DAWES CREEK SUBDIVISION, RESUBDIVISION **OF LOTS 25, 26, 27, 29, 30, AND 31**

APPLICATION NUMBER 18 DATE April 7, 2005

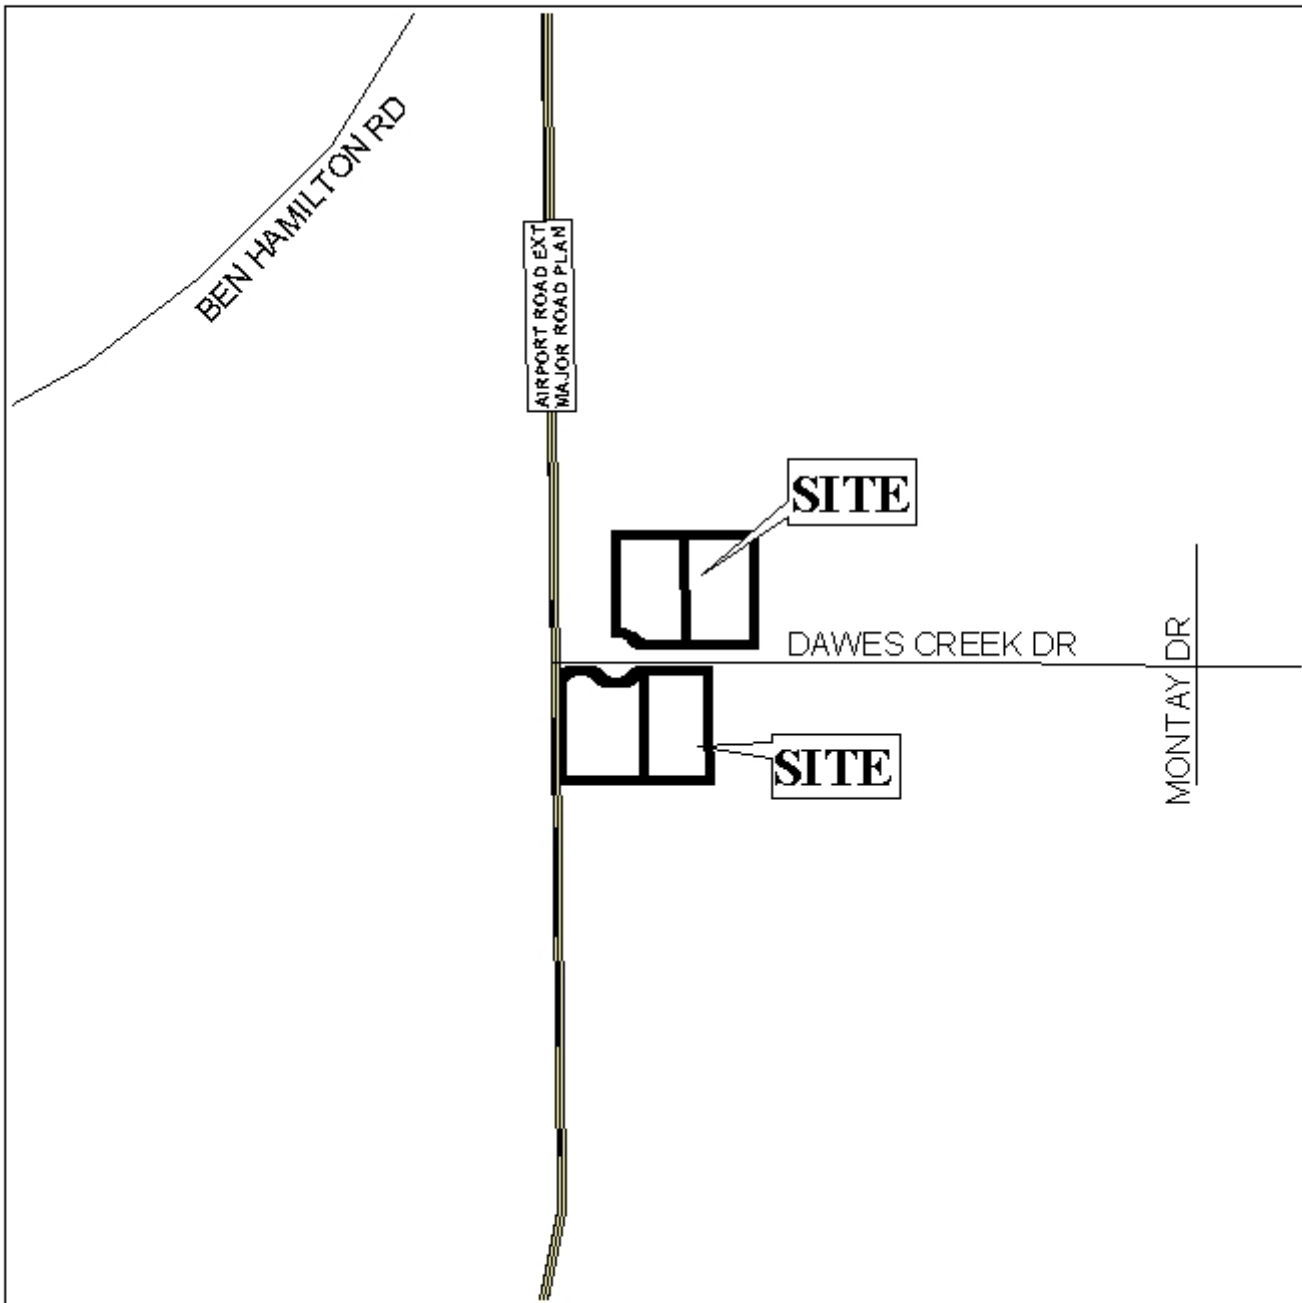
Airport Road, which has an existing right-of-way of 80-feet, is shown as a major street on the Major Street Plan, and as such requires a 100-foot right-of-way; however, there is adequate right-of-way (50-feet) from the centerline of Airport Road to the site. As a means of access management, as illustrated Lot 3 would provide approximately 188-foot of road frontage on Airport Road, a planned major street; therefore, a note should be placed on the final plat stating that Lot 3 is denied direct access to Airport Road, should be required.

Since the site is located in the County, a note should be placed on the final plat stating that any lots which are developed commercially and adjoin residentially developed property, shall provide a buffer, in compliance with Section V.A.7. of the Subdivision Regulations.

The required twenty-five foot minimum building setback lines along Airport Road are not illustrated, but will be required on the final plat.

With modifications, the plat will meet the minimum requirements of the Subdivision Regulations and is recommended for Tentative Approval subject to the following conditions: 1) the placement of a note on the final plat stating that Lot 3 is denied direct access to Airport Road; 2) the placement of a note on the final plat stating that any lot that is developed commercially and adjoins residentially developed property shall provide a buffer, in compliance with Section V.A.7. of the Subdivision Regulations; and 3) placement of the required 25-foot minimum building setback lines on the final plat.
